**1-7 ANDREWS AVENUE AND 26 GLEN STREET, BONDI
NSW**

**COMBINED BCA AND ACCESS 2022
COMPLIANCE REPORT FOR
CONSENT AUTHORITY SUBMISSION**

DATE: 16 OCTOBER 2024
REPORT NO: 2868 – REV E DRAFT
PREPARED FOR: DCN CAPITAL C/- MHNDUNION
PREPARED BY: AM | J² BCA CONSULTING

Figure A – Bin room located at the base of the shaft

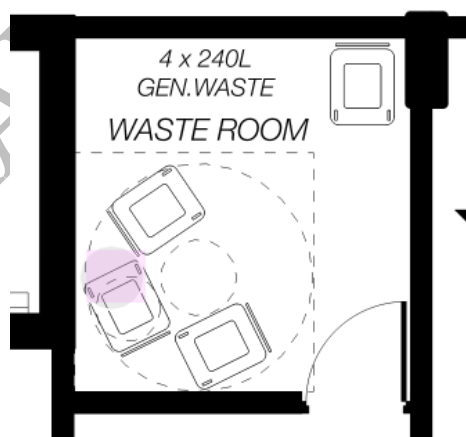
2.	C2D2 <i>C1.1</i> S5C8	Fire Resisting Construction – Enclosure of shafts Shafts which were required to achieve a fire resistance level must be enclosed at the top and bottom by construction achieving a fire resistance level not less than that required for the wall of a non-loadbearing shaft in the same building. This does not apply to the top of a shaft extending beyond the roof covering, other than one enclosing a fire-isolated stairway or ramp or the bottom of a shaft if it is non-combustible and laid directly on the ground. Typically, the garbage shaft located within the building which opens into the bin room does not comply with the provisions of this clause as the waste room contains bins which is an item other than an area reserved for services.	A Fire Engineered Performance Solution may be sought at the Construction Certificate stage of the application.

Figure B – Fire isolated stair and passenger lift are located within the same shaft

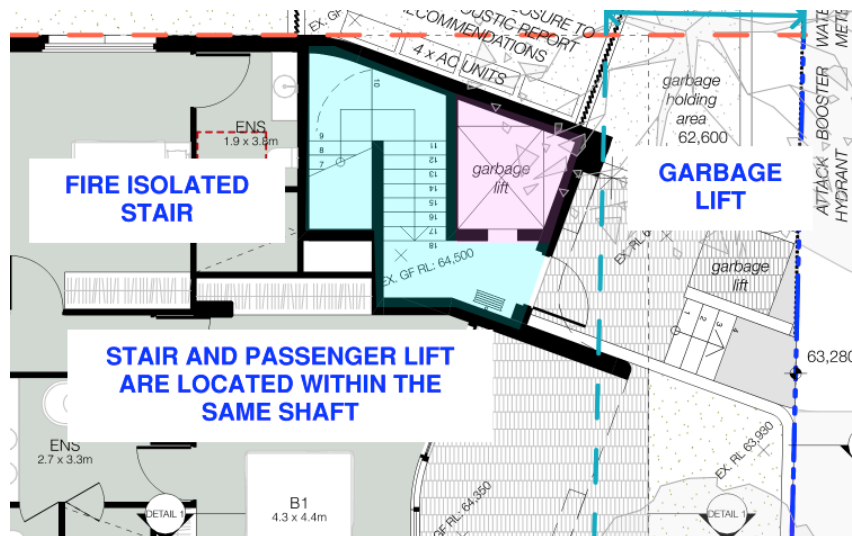
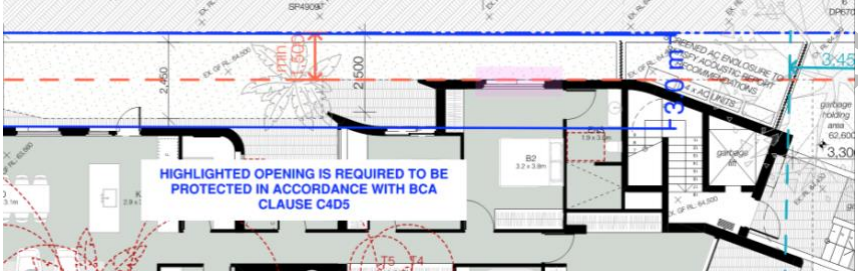
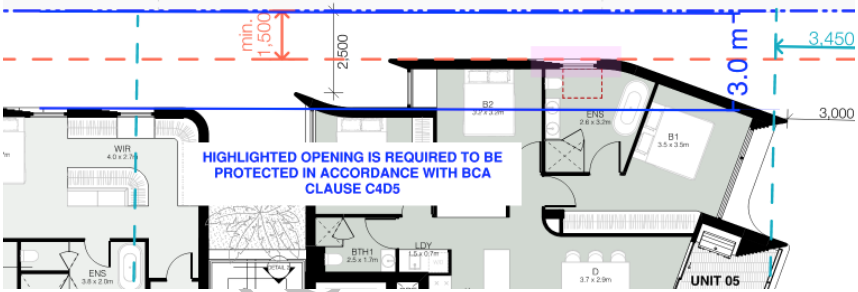
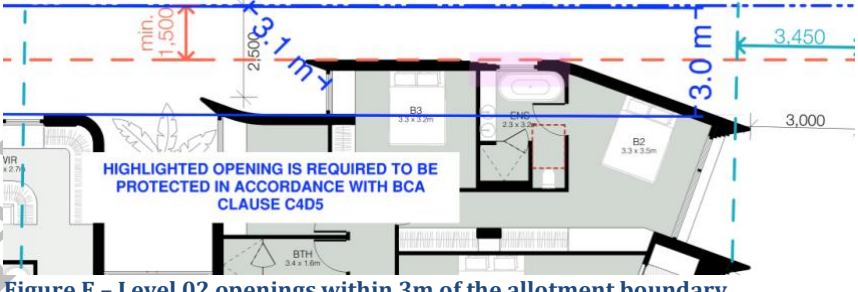
NO.	DTS CLAUSE	DESCRIPTION OF NON-COMPLIANCE	RECOMMENDATION
3.	C3D11 C2.11	Stairways and lifts in one shaft A stairway and lift must not be in the same shaft if either of the stairway or the lift is required to be in a fire-resisting shaft.	To be redesigned to comply.

The garbage passenger lift is located within the same shaft as the fire isolated stair serving the pump room. This arrangement is shown below:

Figure G - Basement Level, distance of travel to a single exit is in the order of 41m

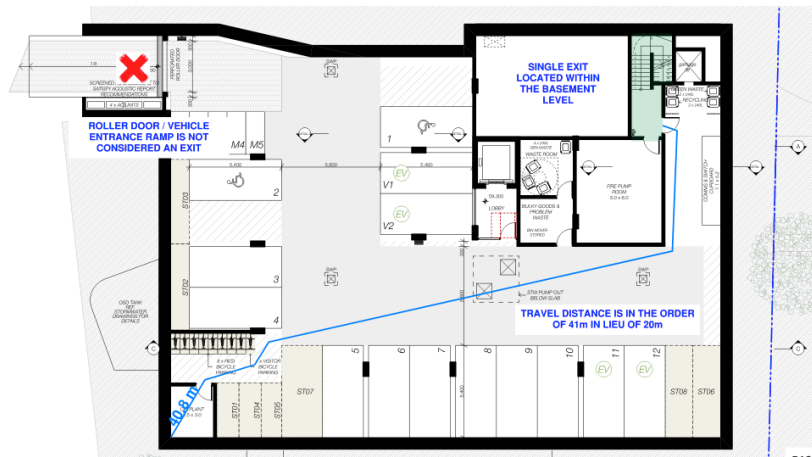
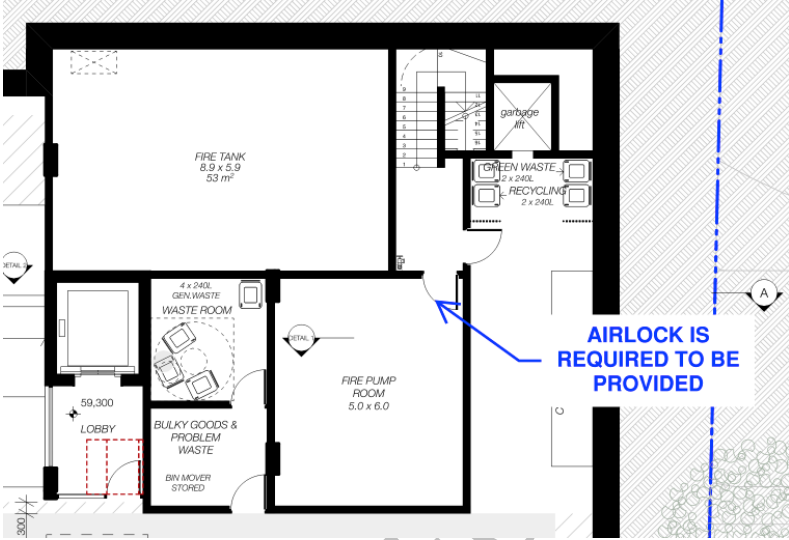
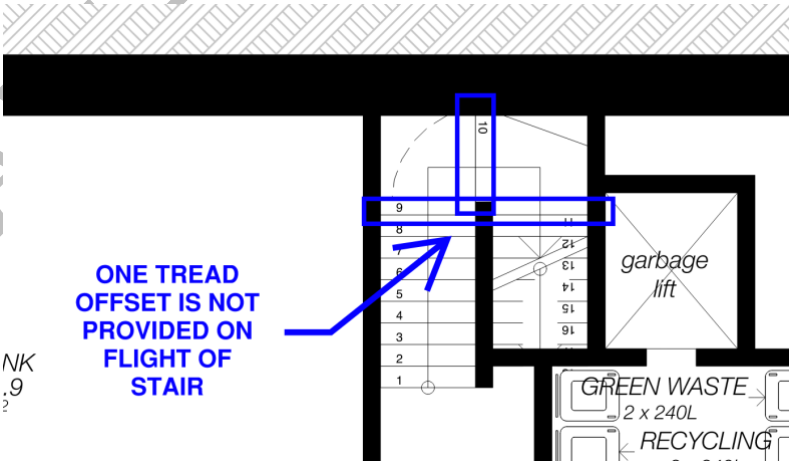
Basement: The basement carparking level is in the order of 41m in lieu of 20m to a single exit. Where a Fire Engineered Performance Solution is undertaken to configure the roller door as an alternative exit compliance with this clause is achieved.

Figure H - Level 1, distance of travel to a single exit is in the order of 7m in lieu of 6m

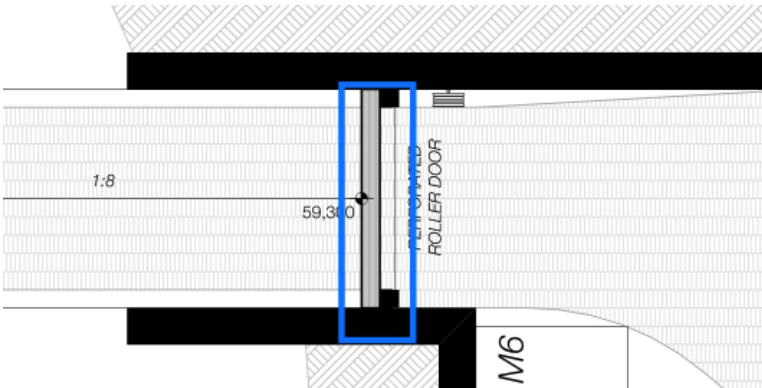
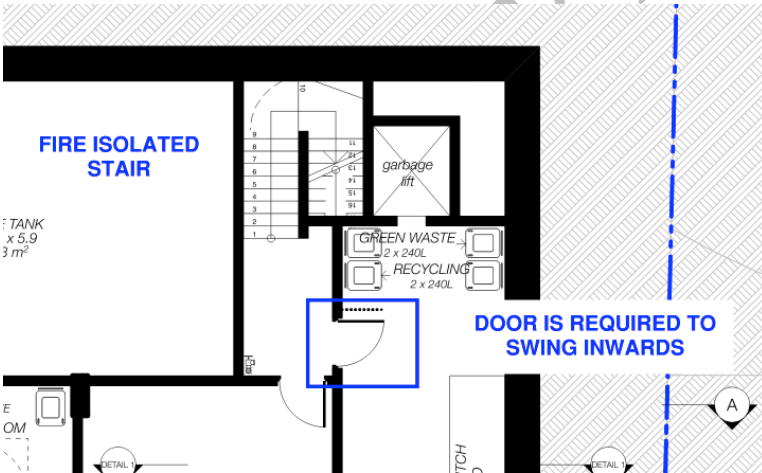
Level 01: Level 01 is provided with a single exit whereby distance to this exit is approximately 7m in lieu of 6m. This is shown below:

Figure L – External door circulation (length) not achieved to the pool Toilet/shower room

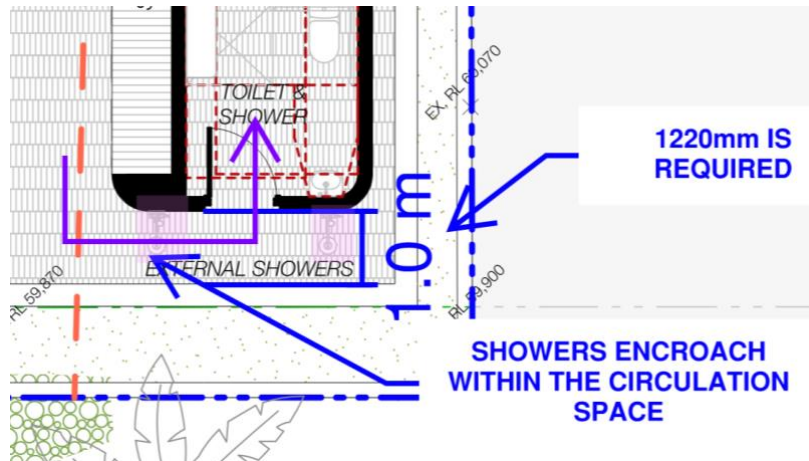
wall which will encroach within the required accessway (requiring 2m unobstructed height clearance).

Figure M – Accessible features are required to the external stair

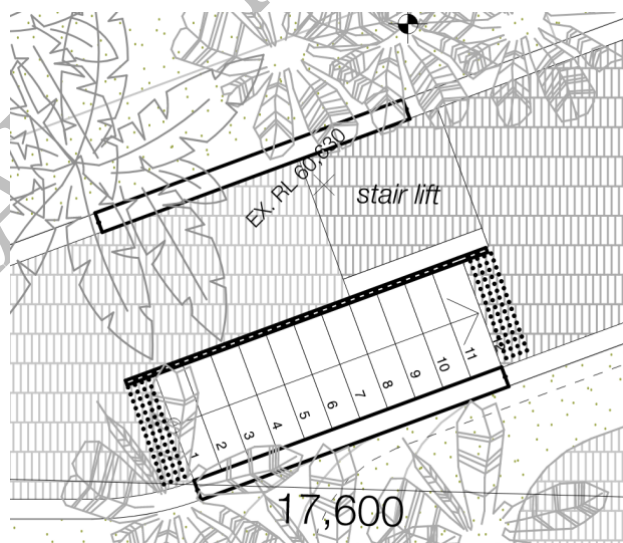
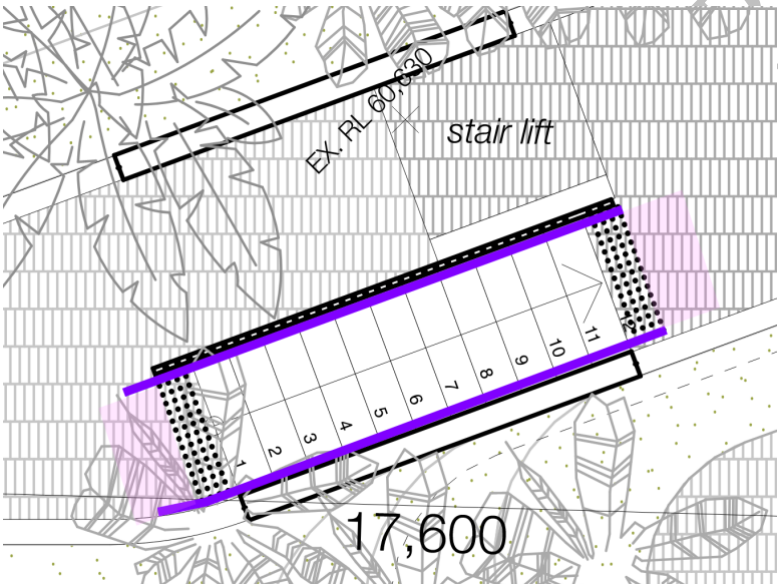
The stairs external stairs are required to be provided with accessible features in accordance with BCA Clause D4D4. These accessible features are not currently detailed within the architectural drawings:

Figure P – Lift access from Glen Lane

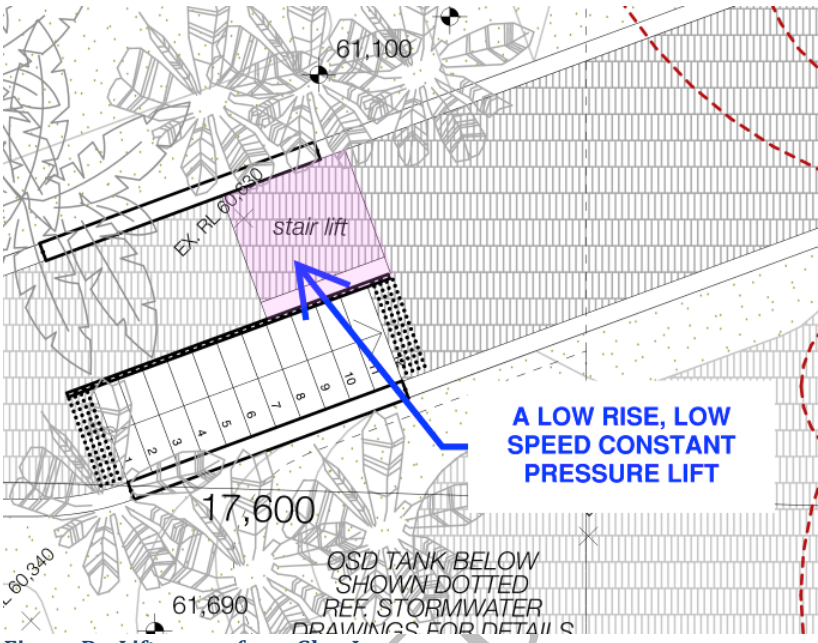
NO.	DTS CLAUSE	DESCRIPTION OF NON-COMPLIANCE	RECOMMENDATION
18.	E3D7 <i>E3.6</i>	<p>Passenger lift types and their limitations</p> <p>Access provided from Glen Lane is provided with a 'stair lift', this appears to contain a vertical change in level greater than 1m, therefore a low-rise, low speed constant pressure lift is required to be provided.</p> 	Note. To be designed to comply.

Figure Q – Handbasin within pool Toilet/Shower room does not meet required setback from side wall

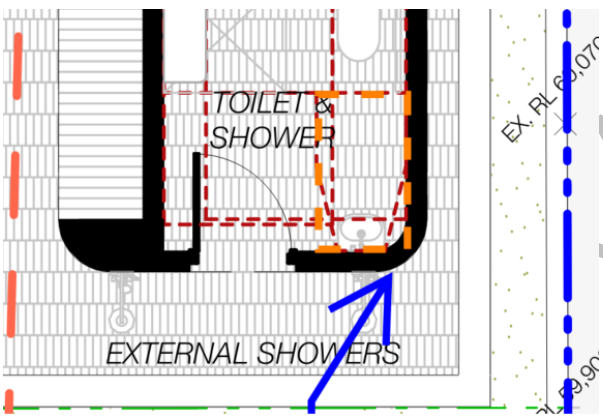
NO.	DTS CLAUSE	DESCRIPTION OF NON-COMPLIANCE	RECOMMENDATION
19.	F4D6 <i>F2.4a</i>	<p>Accessible unisex sanitary compartments</p> <p>In a building required to be accessible, accessible unisex sanitary compartments must be provided within accessible parts of the building in accordance with F4D6.</p> <p>The communal sanitary compartment provided within the outdoor pool area is required to comply with AS1428.1-2009. An accessible unisex sanitary compartment must contain a closet pan, washbasin, shelf or bench top and adequate disposal of sanitary produces.</p> <p>Circulation spaces, fixtures and fittings of all accessible sanitary facilities provided must comply with the requirements of AS1428.1-2009.</p> <p>The handbasin within the pool Toilet/shower room does not achieve the required set back of 425mm between the wall and the centreline of the handbasin due to the curvature of the wall.</p> <p>This is shown below:</p>  <p>VANITY DOES NOT ACHIEVE 425mm FROM CENTRELINE OF BASIN TO WALL</p>	To be redesigned at the Construction Certificate stage to achieve compliance with this clause.

Figure 4 - Ground floor openings within 3m of the allotment boundary

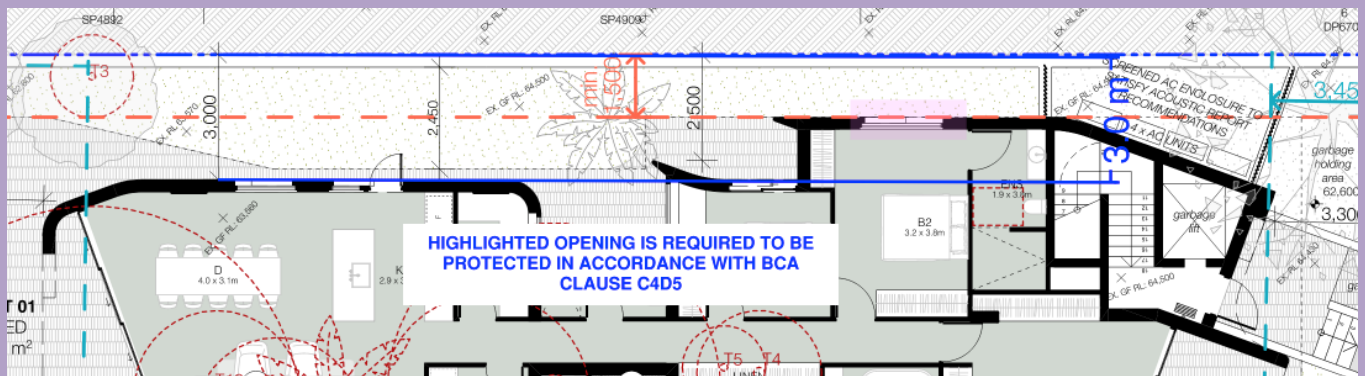
CLAUSE	REFERENCE	APPLICABLE	COMPLIES	COMMENT
				<p>storey at or near ground level or 6m from another building on the allotment that is not a Class 10.</p> <p>Openings are proposed to be located within 3m of the allotment boundary. The affected openings are highlighted below.</p> <p>Note, the openings serving bedrooms are required to be openable to achieve natural light and ventilation in accordance with BCA Part F4. These windows are not permitted to be fixed closed.</p> <p>To be redesigned to comply or a Fire Engineered Performance Solution is required to address this item.</p>

Figure 9 – Basement Level, distance of travel to a single exit is in the order of 41m

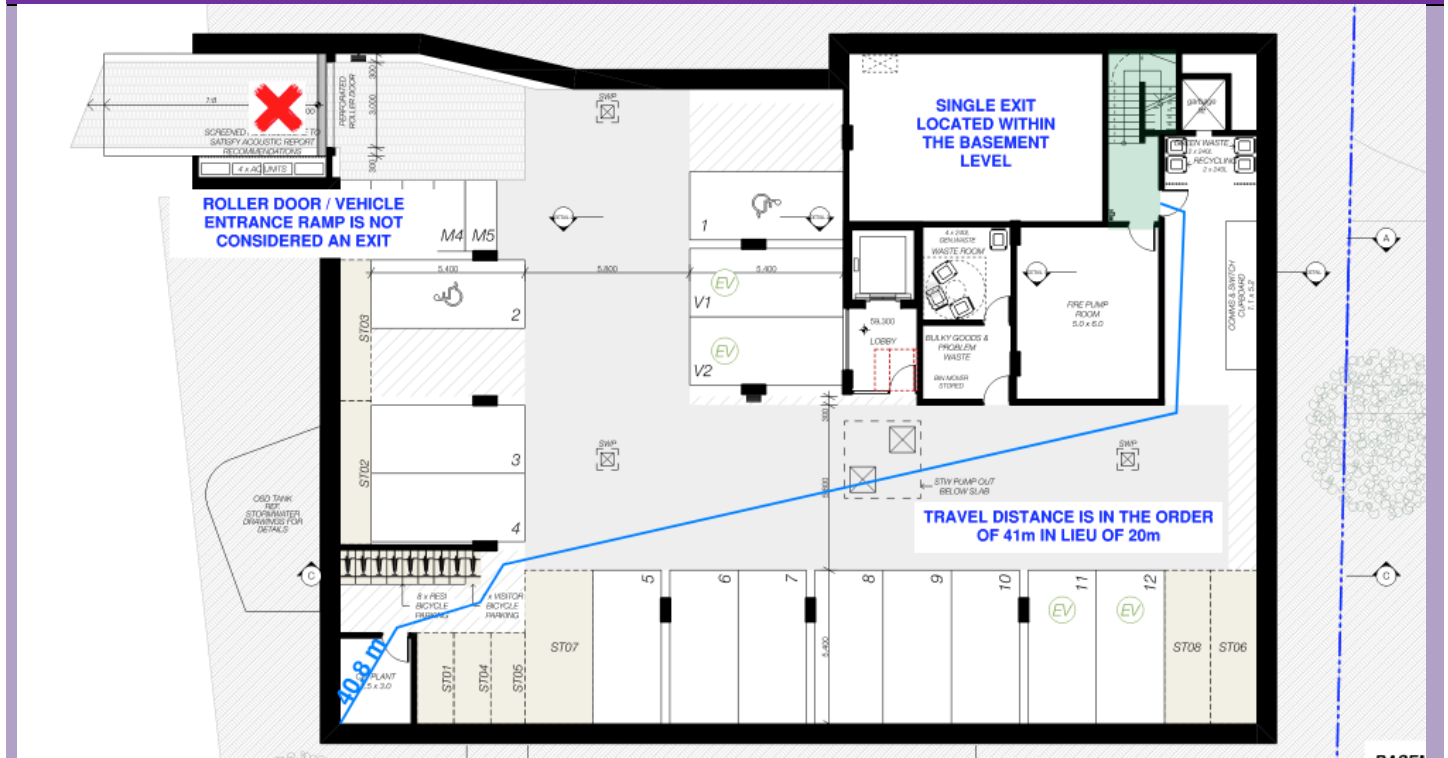
CLAUSE	REFERENCE	APPLICABLE	COMPLIES	COMMENT
				<p>in this calculation where a sprinkler system (other than an FPAA101D system is installed). It is recommended that an AS2118 sprinkler system is installed throughout the building (alternatively an FPAA101H system may be installed).</p> <p>In a Class 7 building every stairway or ramp serving as a required exit must be fire isolated where connecting more than two storeys. The stair serving the basement level appears to be fire isolated (required where accessing the pump room).</p>
D2D5 D1.4	Exit Travel Distances	✓	X	<p><u>Class 7a parts of the buildings –</u> No point on a floor must be more than 20m from an exit, or a point from which travel in different directions to two exits is available, in which case the maximum distance to one of those exits must not exceed 40m; and</p> <p><u>Class 2 parts of the buildings –</u> The entrance doorway of any sole-occupancy unit must be not more than 6m from an exit or from a point from which travel in different directions to two exits is available or 20m from a single exit.</p> <p>Additionally, no point on the floor of a room which is not in a sole-occupancy unit must be more than 20m from an exit or from a point at which travel in different directions to two exits is available.</p> <p><u>Basement:</u> The basement carparking level is in the order of 41m in lieu of 20m to a single exit. Where a Fire Engineered Performance Solution is undertaken to configure the roller door as an alternative exit compliance with this clause is achieved.</p> <p><u>Ground Floor:</u> The residential SOUs located on the ground floor are located within 20m of a single exit. This is considered generally compliant.</p> <p>As the pool/sanitary compartment is provided with direct egress to the road (Glen Lane). This is not considered an occupiable outdoor area.</p> <p><u>Level 01:</u> Level 01 is provided with a single exit whereby distance to this exit is approximately 7m in lieu of 6m. This is shown below.</p> <p><u>Remaining Residential SOU levels:</u> Distance of travel is within 6m to a single exit.</p>
